Consideration of Update to ICR Proposal

IEEE 802.3ap 9/28/05 Channel
Ad Hoc Call,
dambrosia_c1_0905

Tyco Case #4

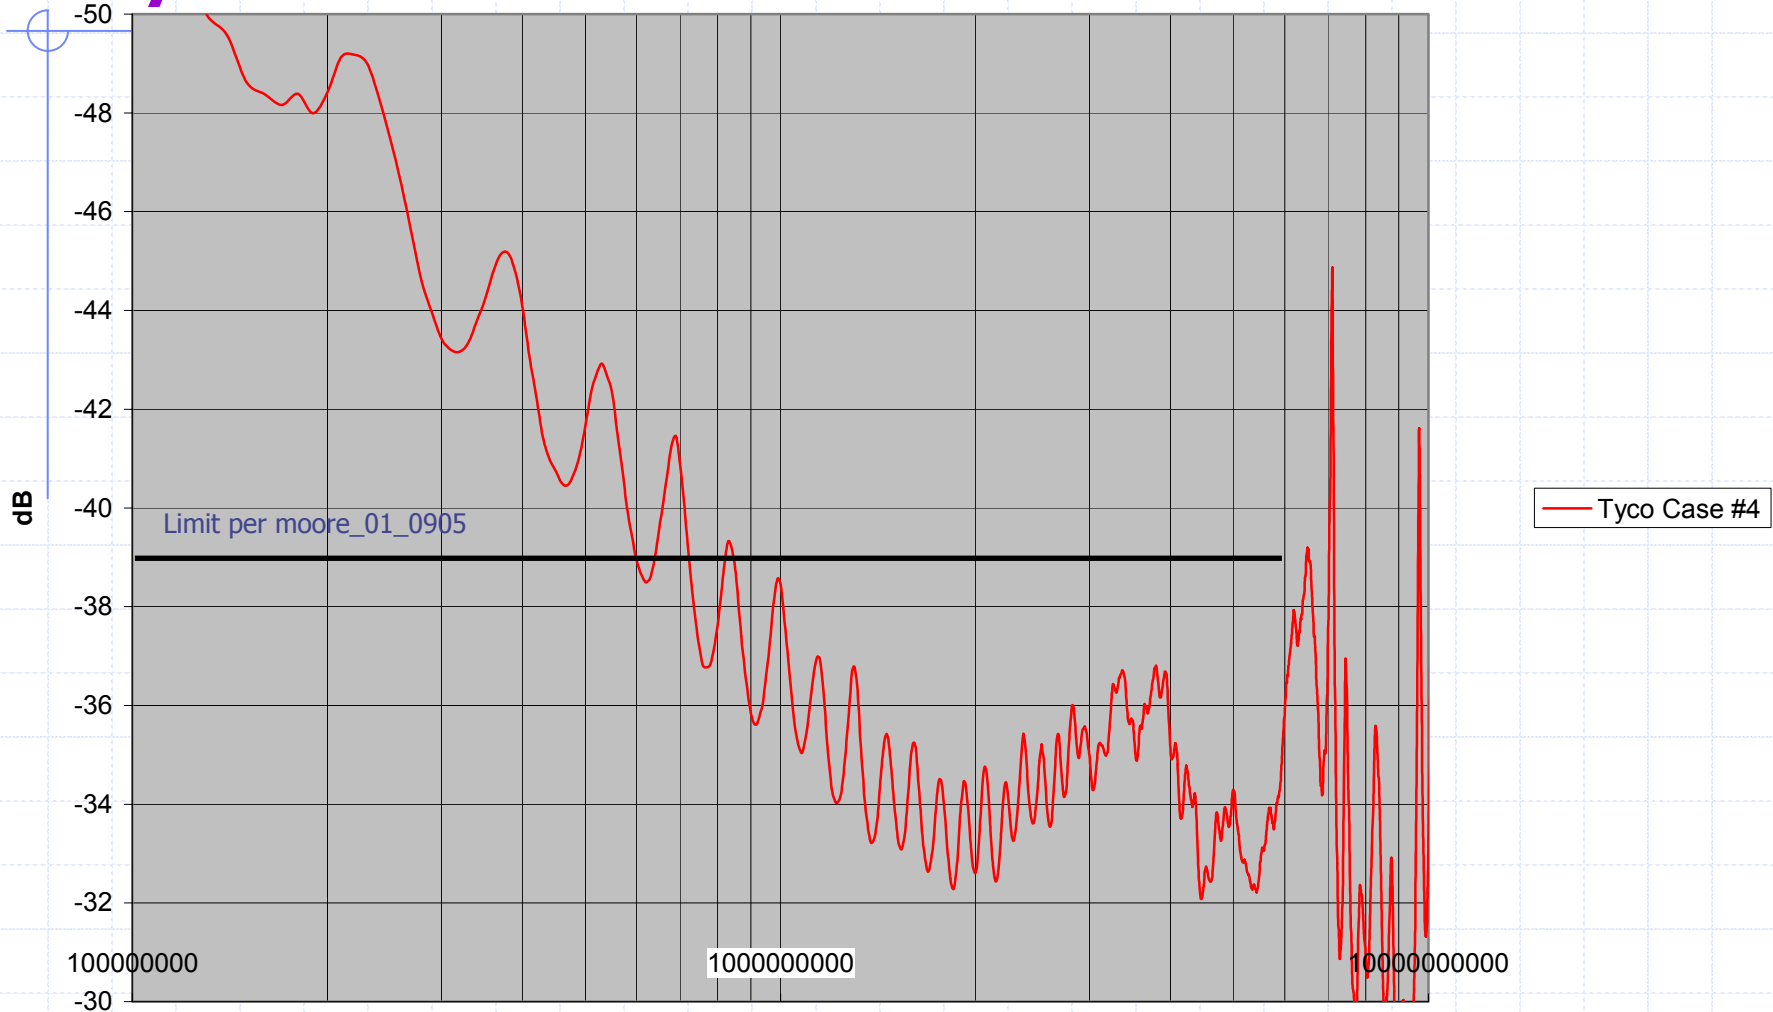
- Crosstalk spectra of channel is not flat
- 15 channels considered
 - 7 cases from Tyco
 - 8 cases from Molex
 - (Intel analysis not completed due to findings of first 15 cases
 - No channel, regardless of SDD21 profile, came close to meeting moore_01_0905 proposal
